Lamphier-Gregory

SUBJECT: Head Royce PUD Project, CEQA Appeal of the Oakland Planning Commission's CEQA Determination

DATE: August 15, 2023

This memorandum provides responses to the Appeal of the Oakland Planning Commission's April 19, 2023 CEQA Determination and approval of the Head Royce School's PUD Project.

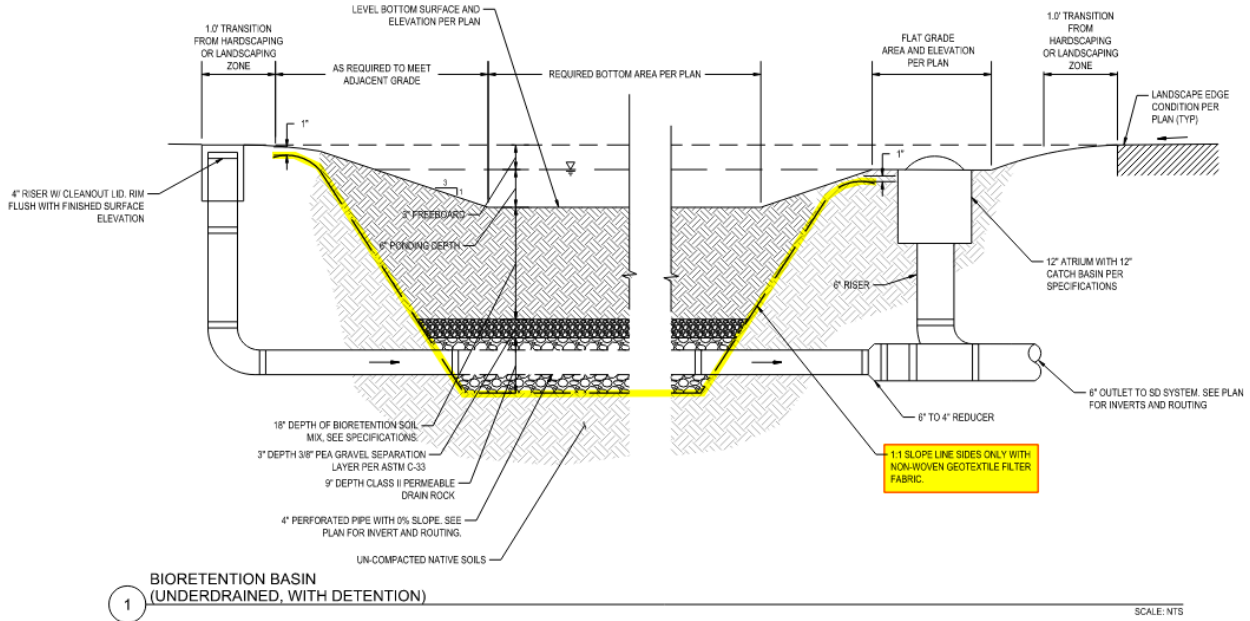
The appeal indicated that the appellant has been unable to find a final drainage plan showing the changes referenced in the Final EIR, demonstrating how drainage near two off-site properties will be handled. The appeal requests an answer to this question.

Pursuant to the recommendations of the Project's geotechnical engineering consultant (Rockridge Geotechnical), the Project does propose to line the retention basins that are to be located south of the Loop Road and to connect these retention basins with underground pipe, rather than earthen bottom basins and an open swale. See the detail drawing from Sheet C7.04 of the Final Development Plan's Engineering Plan Set (below), which does call for geotextile lining and piping.
